<b>ITEM: 6.4</b>	<b>REPORT SUMMARY MINOR VARIANCE APPLICATION FILE NUMBER A018/24</b>
------------------	--

## MINOR VARIANCE APPLICATION FILE NUMBER A018/24

<b>CITY WARD #:</b>	3
<b>APPLICANT:</b>	Sandro & Salvatore Romano
<b>AGENT:</b>	Stepan Sukiasyan
<b>PROPERTY:</b>	93 Rosshaven Crescent, Woodbridge
<b>ZONING DESIGNATION:</b>	See below.
<b>VAUGHAN OFFICIAL PLAN (2010) DESIGNATION:</b>	Vaughan Official Plan 2010 ('VOP 2010'): "Low Density Residential", Volume 2, Area Specific Policy 12.13 - Block 40/47.
<b>RELATED DEVELOPMENT APPLICATIONS:</b>	None
<b>PURPOSE OF APPLICATION:</b>	Relief from the Zoning By-law is being requested to permit a proposed cabana and reduced front yard landscaping requirements.

**93 ROSSHAVEN CRES. WOODBRIDGE, ON**  
PROP. CABANA & SITE ALTERATION

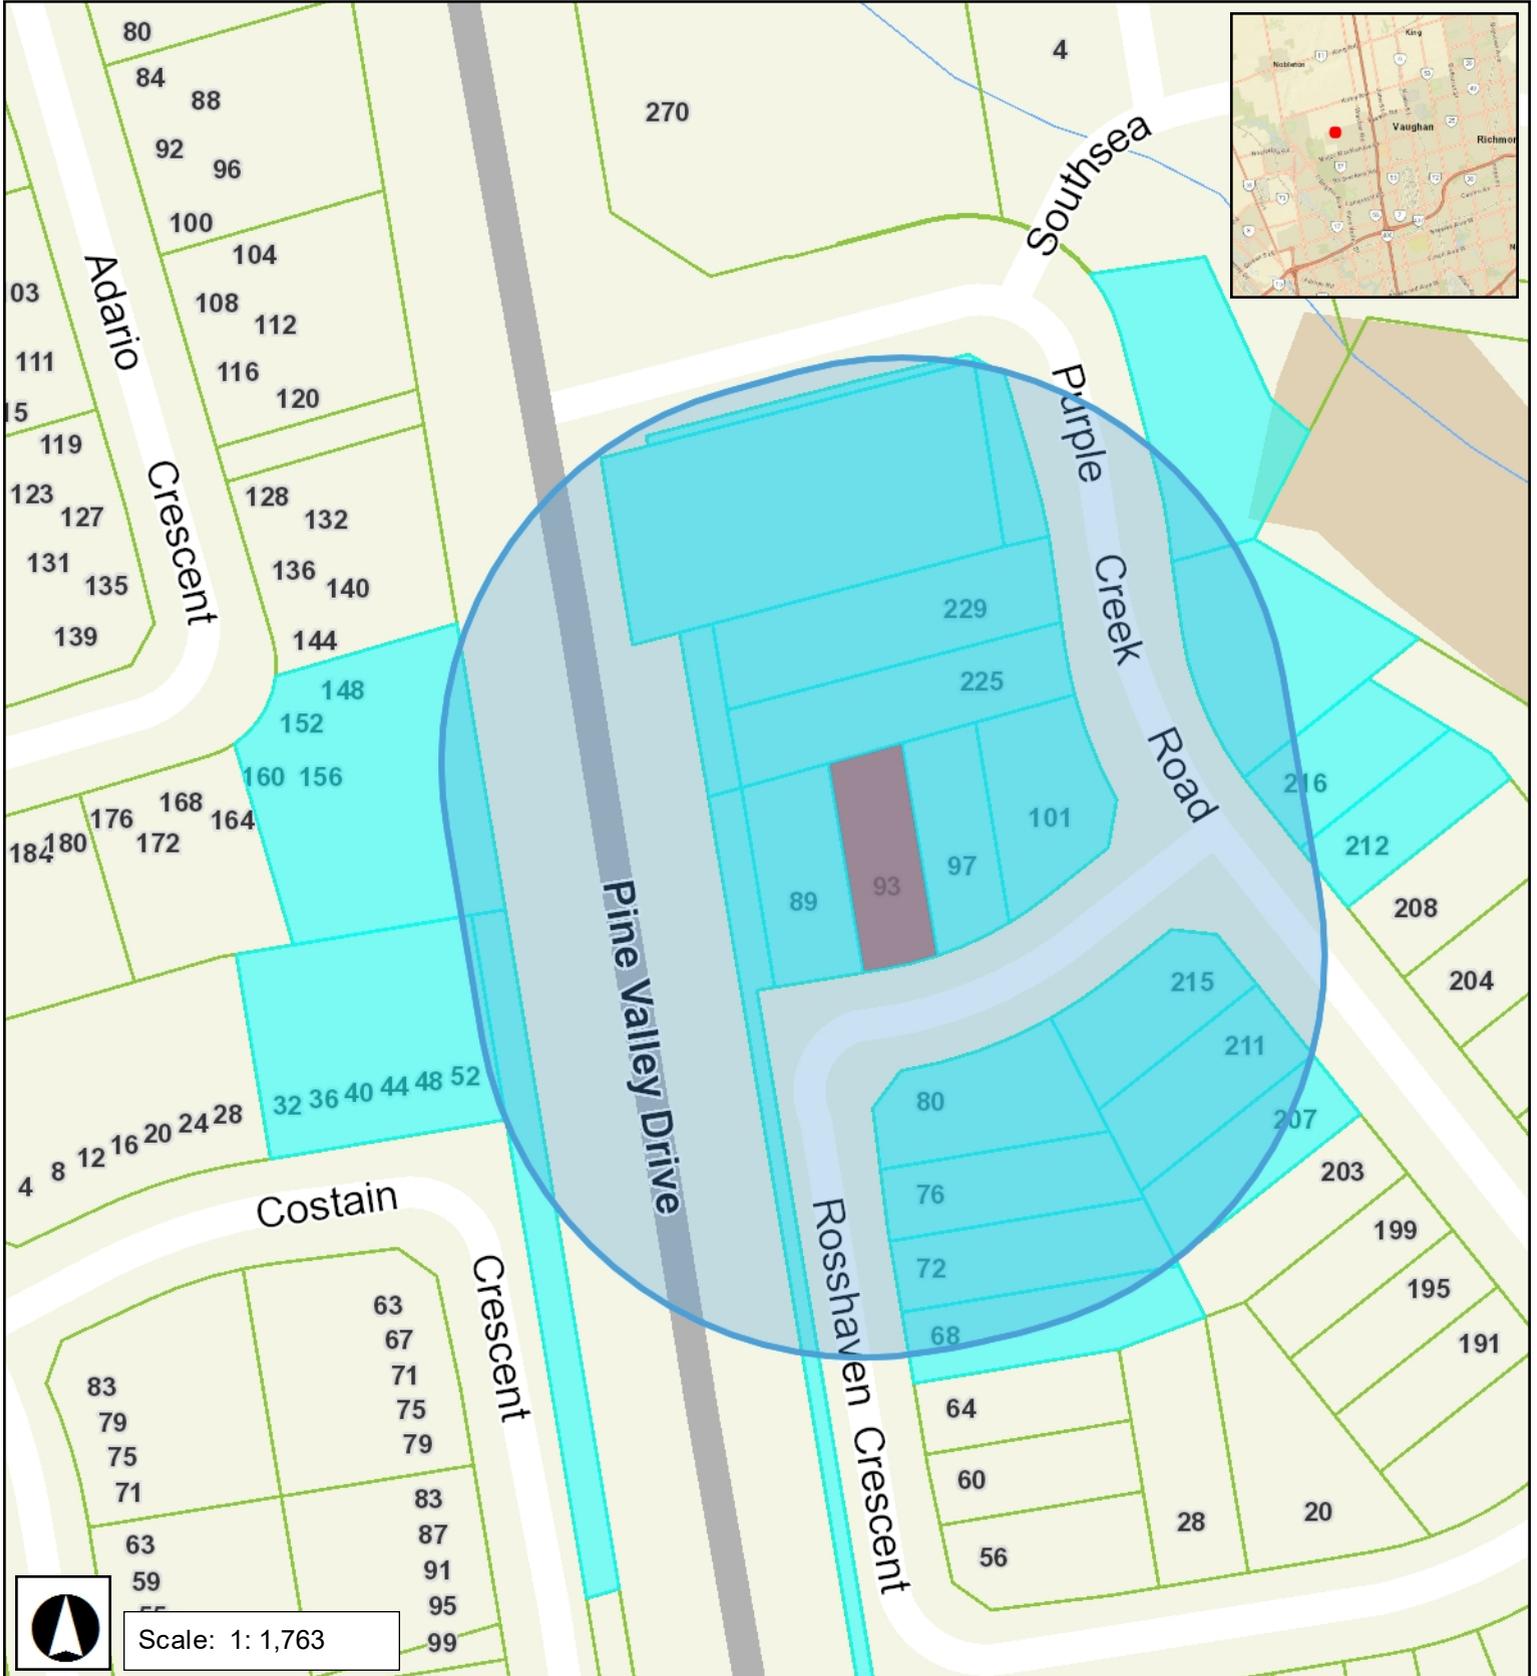
Please note that Development Planning Staff have had the opportunity to review the updated drawings and updated variances and staff are concerned with the landscaping and soft landscaping totals in the front yard (Variances 4 and 5) as they are significantly under the Zoning By-law requirements.

Development Planning Staff suggest reducing the driveway and replacing it with grass in the 3 locations highlighted in green in the attached image below which will bring the front yard landscaping much closer to the By-law requirements and to a total percentage that staff would be in a position to support. This recommendation still maintains walkways to access both side yards. If the applicant has alternative solutions to increase landscaping and soft landscaping totals in the front yard, staff are open to reviewing them.

Please revise the site plan to include increased soft landscaping totals at your earliest convenience as this information is necessary for staff to complete their review and provide recommendations in a staff report due next week for the review of the committee. Please note that these revisions will not impact your position on the April 4<sup>th</sup> agenda as these revisions would only decrease the variance required.

On March 25, 2024, the applicant provided revised plans to address Development Planning comments.

On March 25, 2024, Building Standards provided revised comments confirming required variances. Variances #4 and #5 pertaining to front yard landscaping were increased from what was provided in the statutory public notice.
